Product Change Notification

Product Group: Opto Modules & Visibles 23-APR-2021 / PCN OMV-1179-2021 Rev. 0

TITLE: Redesign of IL300 Linear optocoupler product series

Details of Changes to IL300 Series Addressed in PCN OMV-1179-2021

Package Dimension: The package still conforms to the JEDEC standard, some of the dimensions have slight changes.

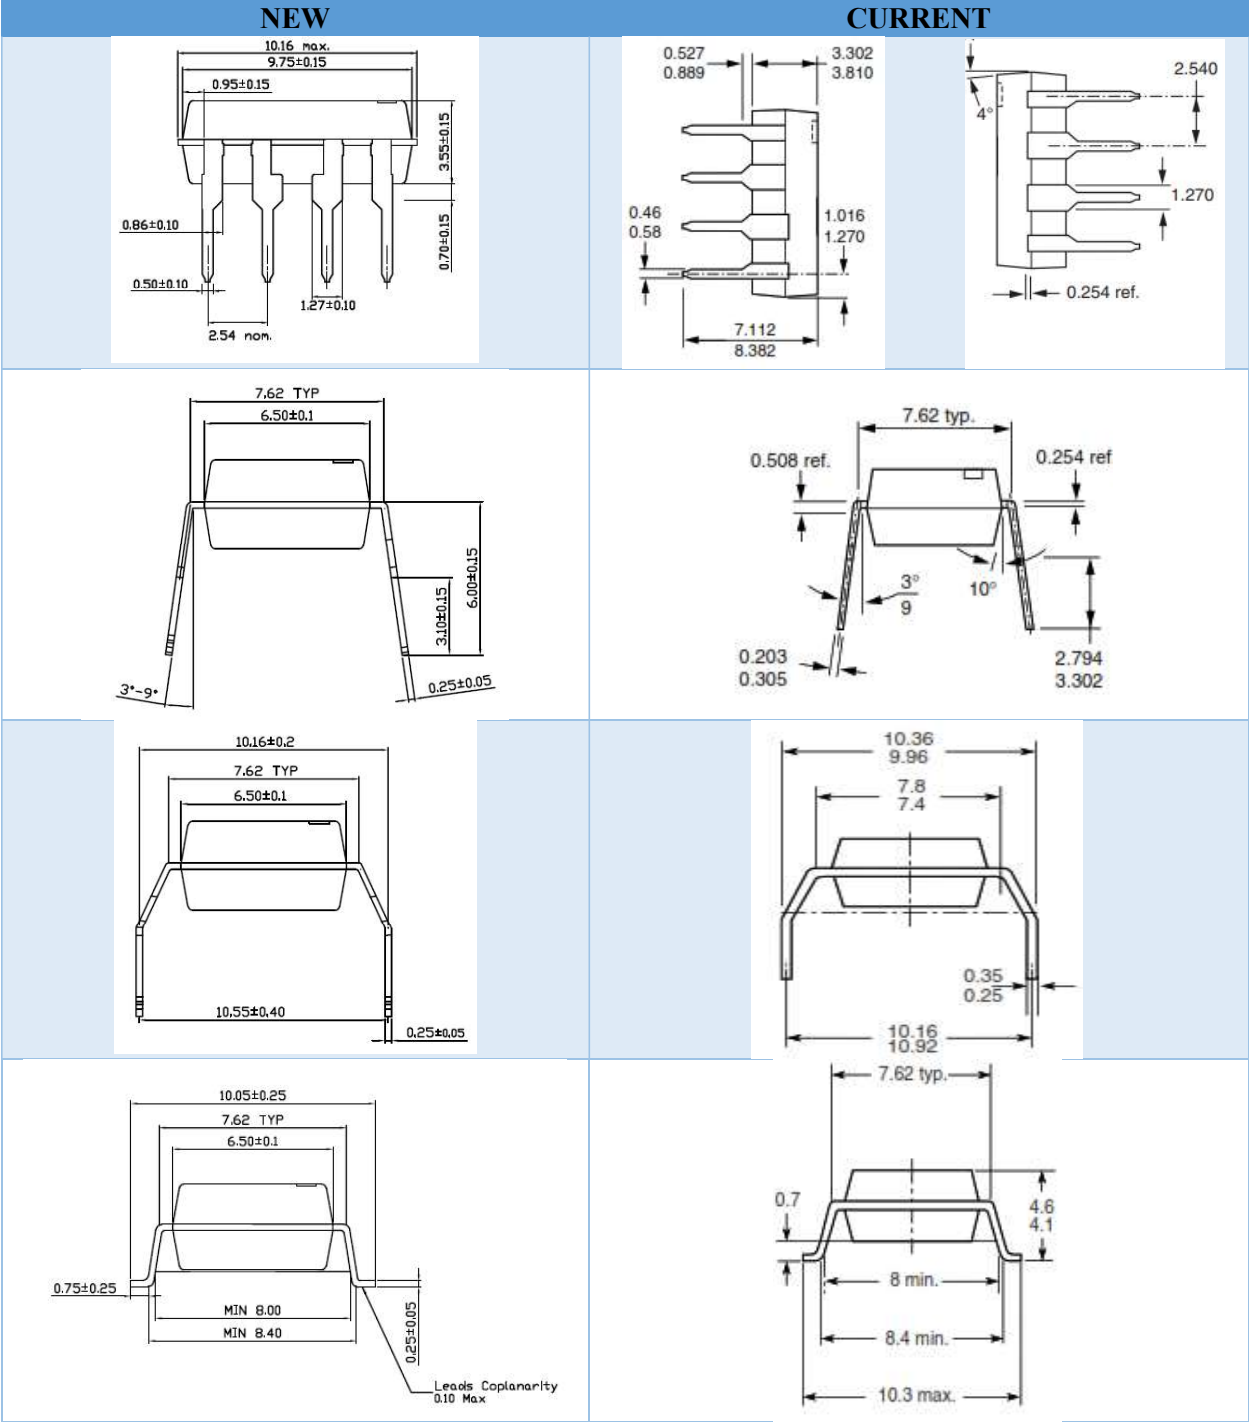
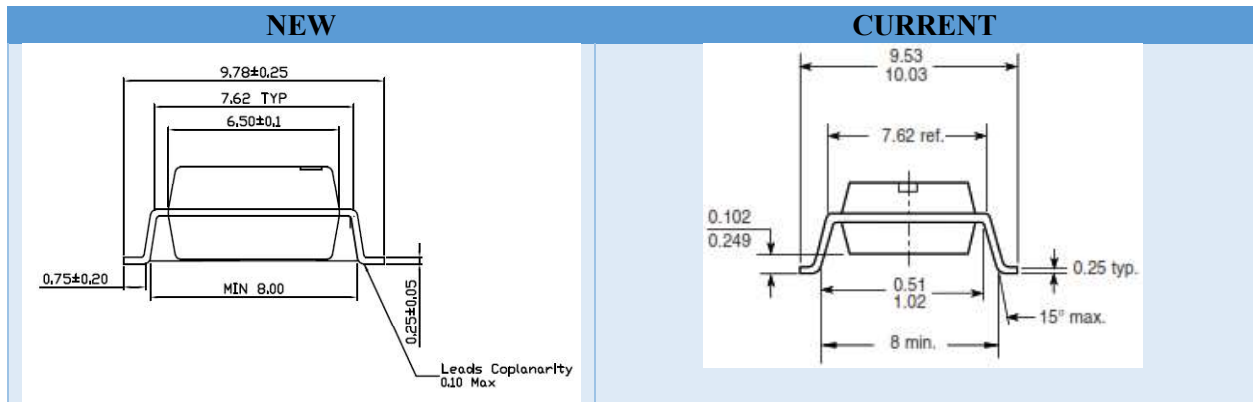
The package has been redesigned resulting in several changes. The most notable of these changes is the colour of the outer molding compound. Less noticeable is the change in construction and the change in package dimensions.

3.8 Characteristics

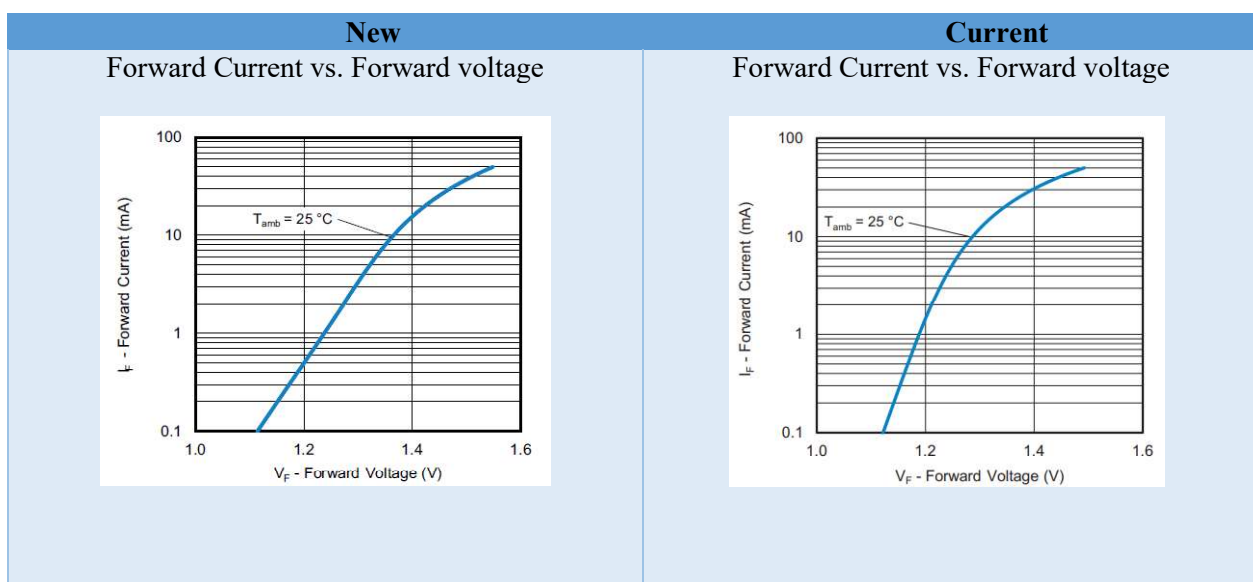
Detailed product characterization has been performed on this series of products. Some slight changes in electrical parameters and performance were observed.
